JULY 30, 2025

CONTRACT NO. 1800

WET WEATHER PUMP STATION

ADDENDUM NO. 6

Designed by:	REVISION			
M.CONTI	REV No.	DATE	DESCRIPTION	APPV
Drawn by:	0	5/16/25	ISSUE FOR BID	CKM
S.GRAMKOW	1	07/31/25	ADD. 6 - REVISED DETAILS, NOTES, & FINISH SCHEDULE	CKM
Checked by:				
D.WALDROP

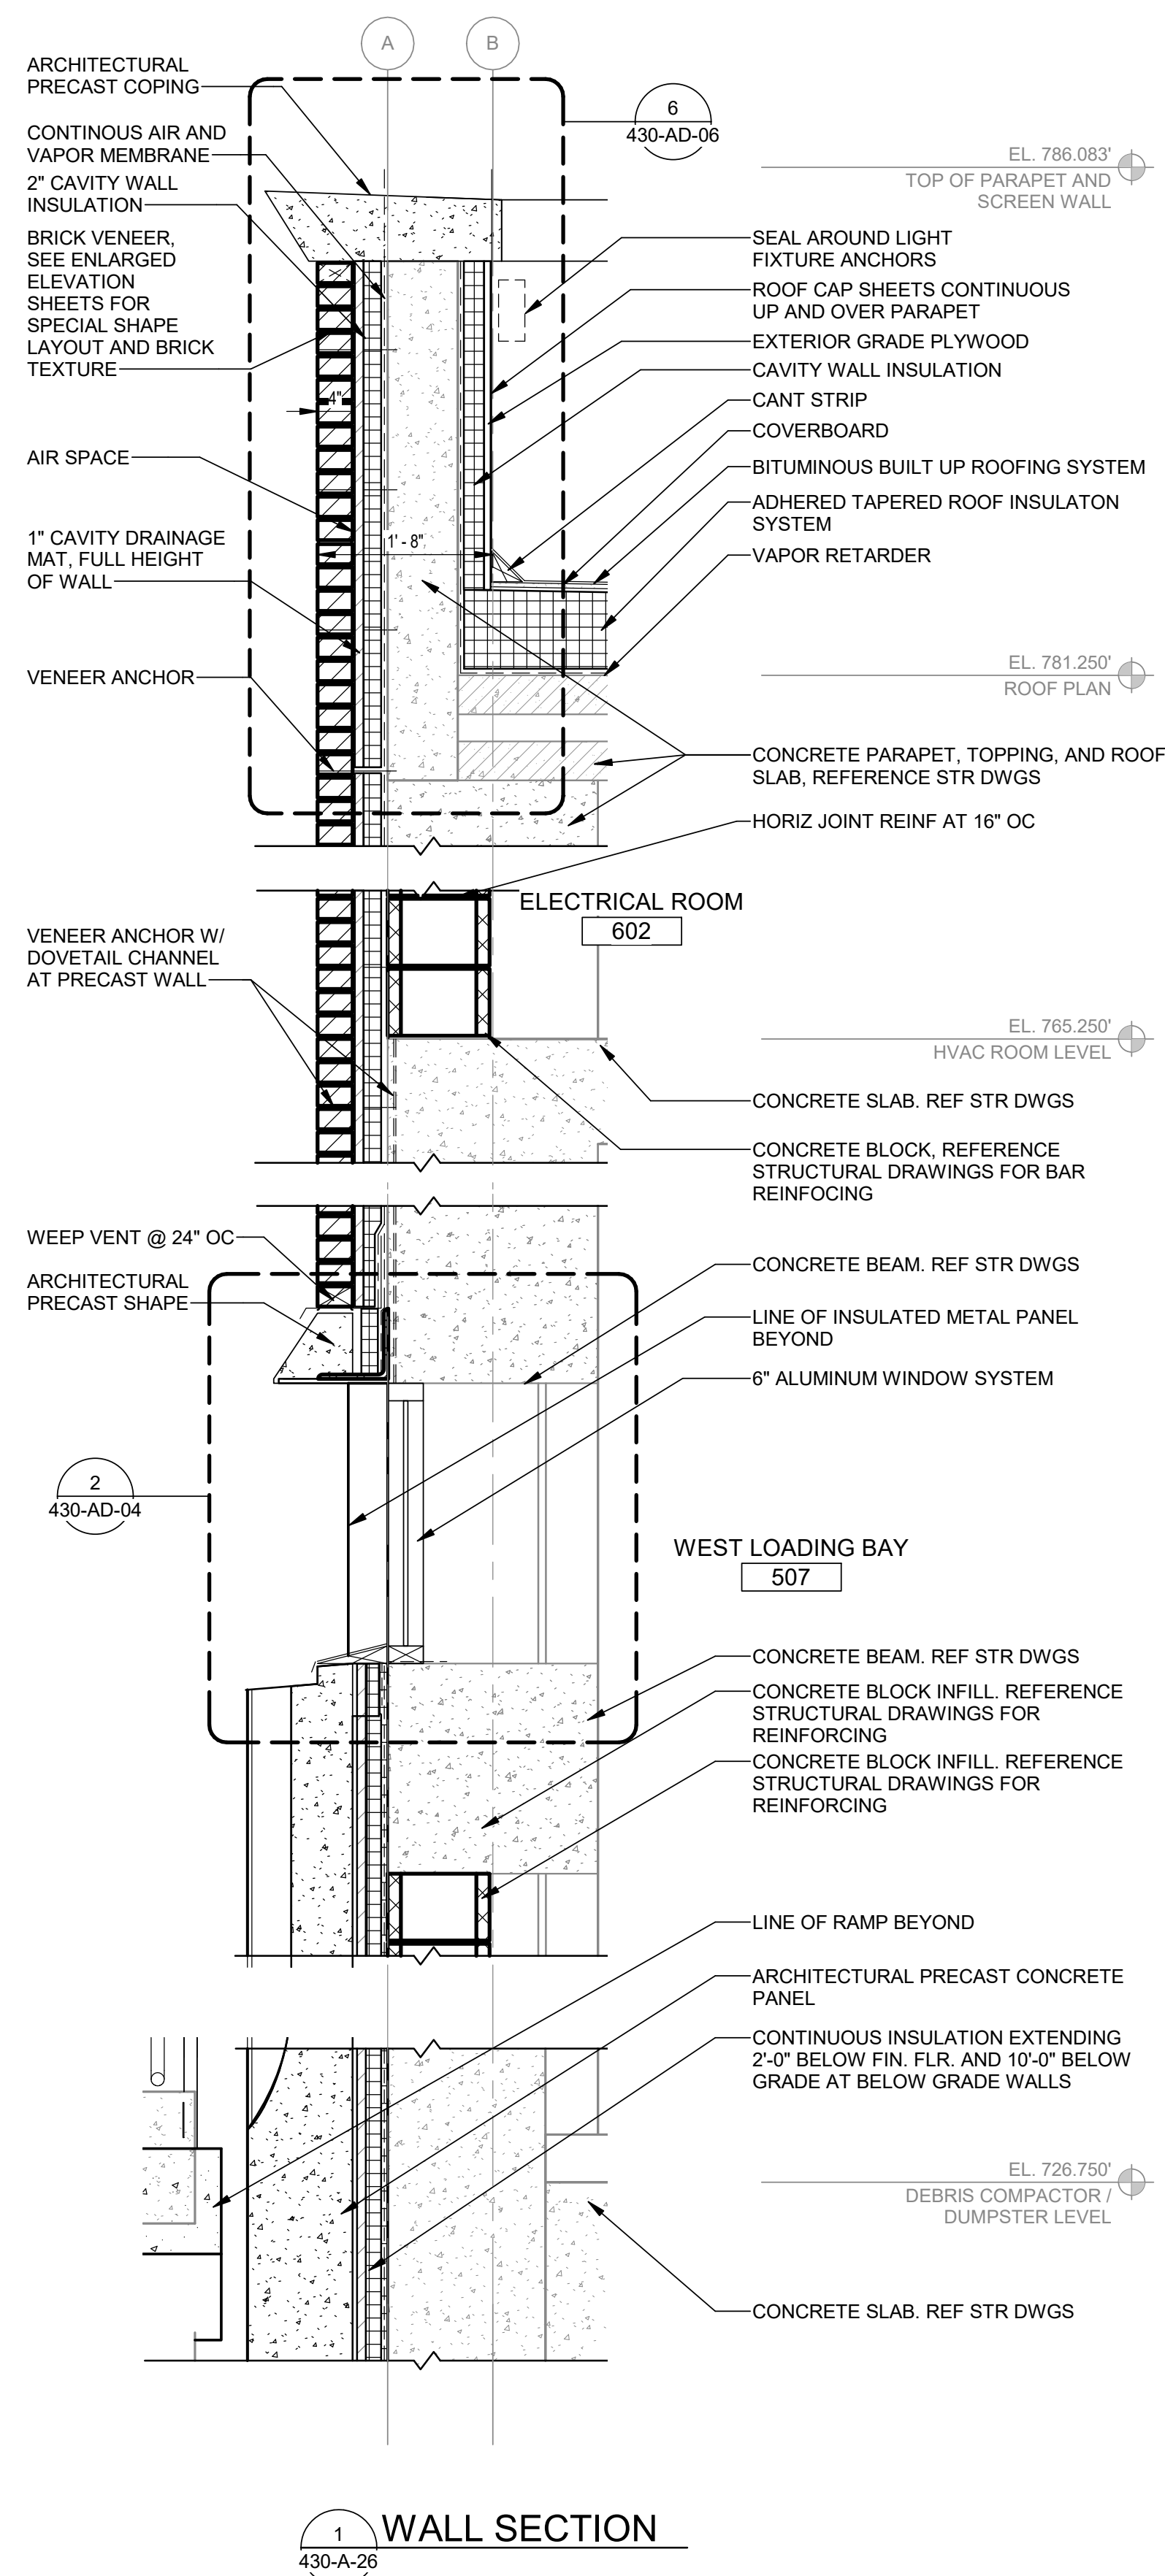
Q48: Detail 2 on Drawing 430-A-28 shows the insulated metal panel on the walls and ceiling, while room finish schedule indicates concrete ceiling within room 401. Please clarify the ceiling finish type for room 401.

A48: In Room 401, the insulated metal panel at the ceiling is intended to provide insulation for the breezeway above. The extents of the metal panel in the east/west direction should be from 1' south of grid E and 1' east of grid F. In the north/south direction, it should extend from the wall of the wetwell at the south to the wall of the discharge chamber at the north. Refer to Item 4.2 of Addendum No. 6.

430-AD-09
FIRE STOPPING DETAILS 2

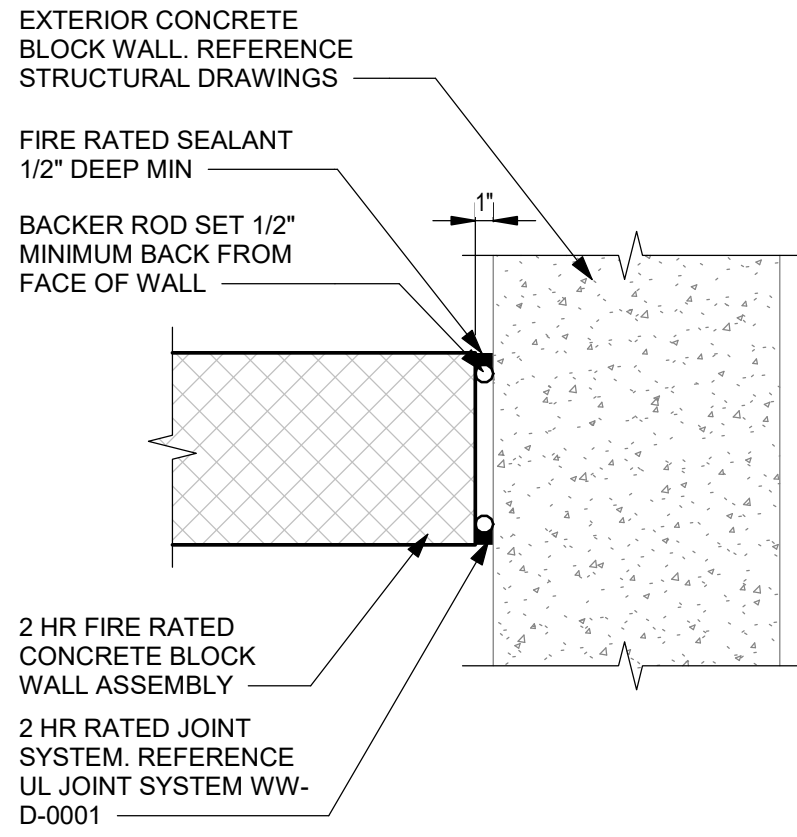
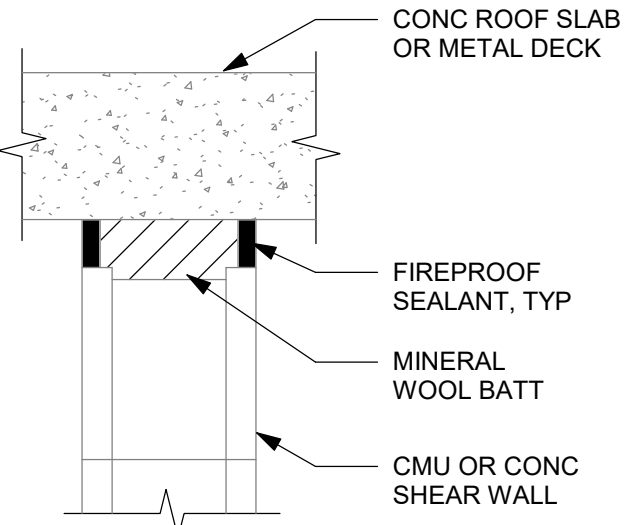
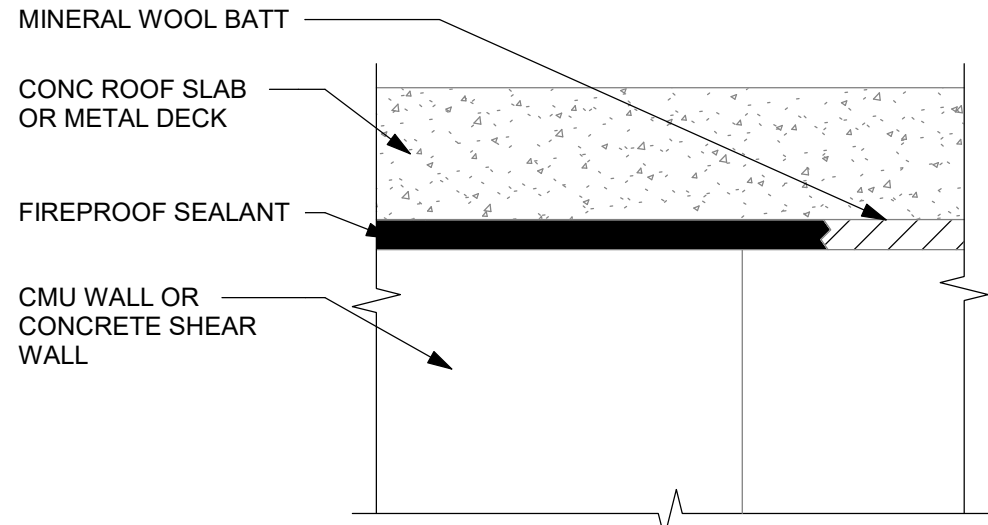
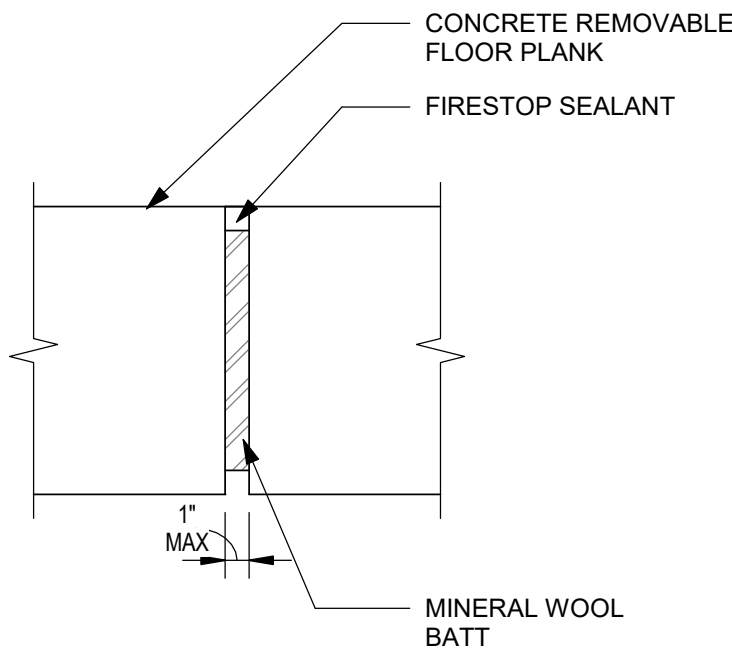
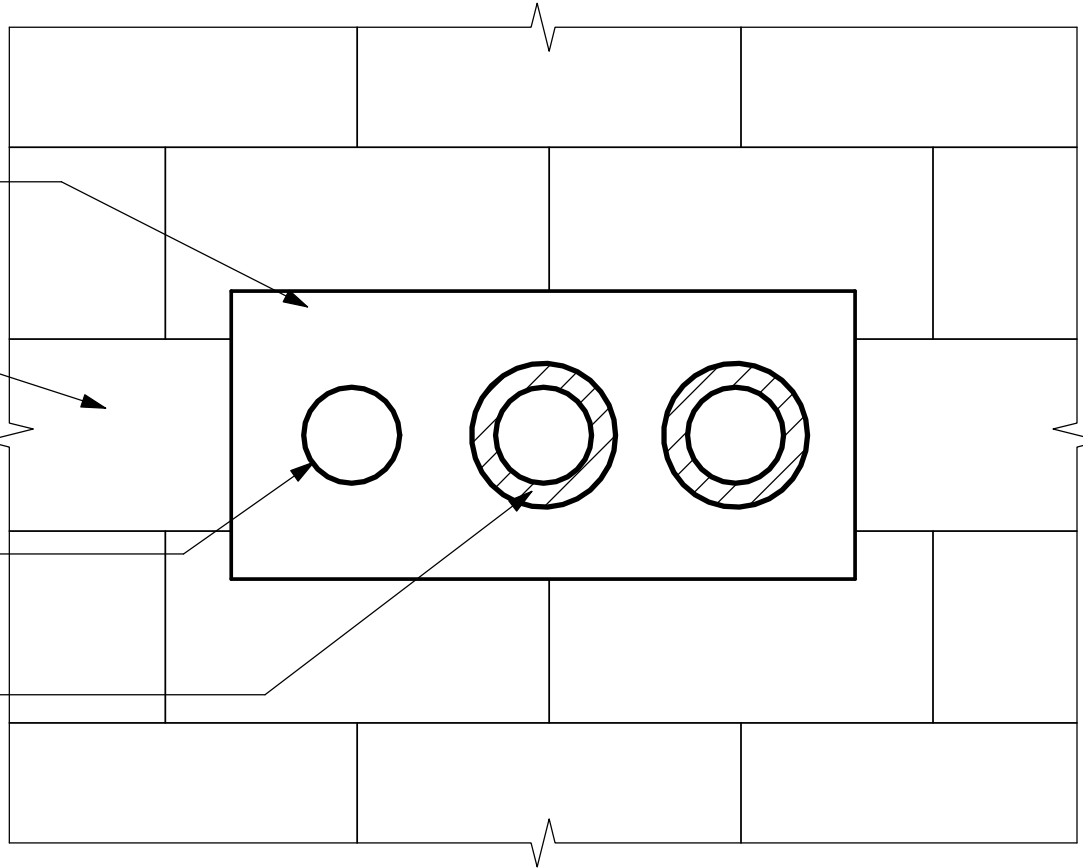
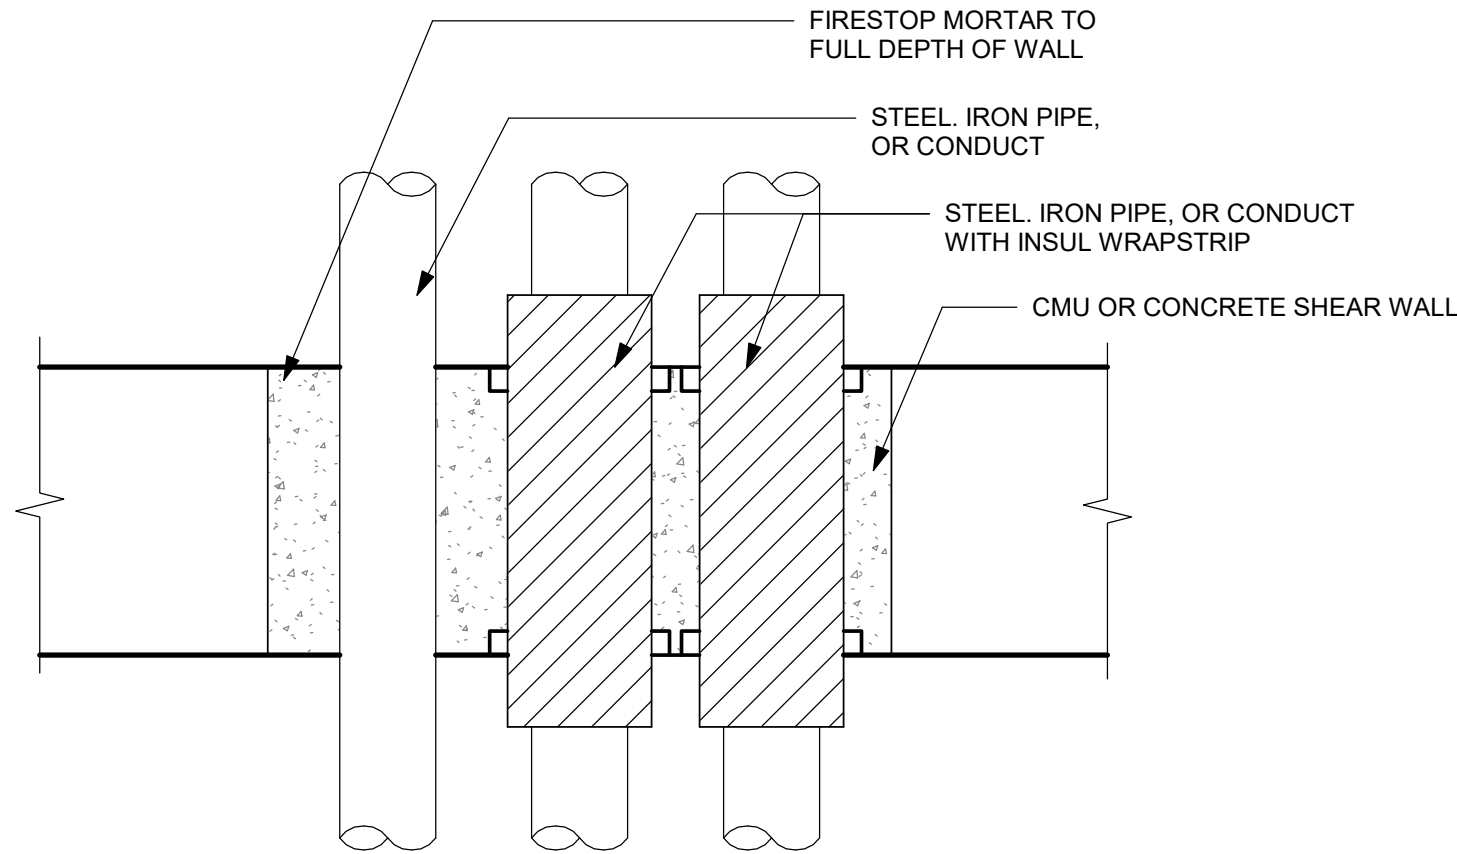
- A5:** Site improvements not identified for demolition in the contract drawings shall be protected from damage.
- Q6:** Reference drawing 430-AD-09 Fire Stopping Details 2 : Detail 4 references firestopping between 8" CMU and concrete roof slab but does not specify if it also applies between 8" CMU and the concrete deck in the electrical room or other floor slabs. Please confirm if this firestopping system also applies between 8" CMU and the concrete deck in the electrical room or other floor slabs for this project.

- Q7:** Reference drawing 430-AD-09 detail 3 : We cannot find a reference in the plans to this detail. Where does this condition occur ?
- A7:** This detail is not used. Refer to Item 4.2 of Addendum No. 6. .

- A6:** This fire stopping detail applies at the rated walls of the electrical room and all other
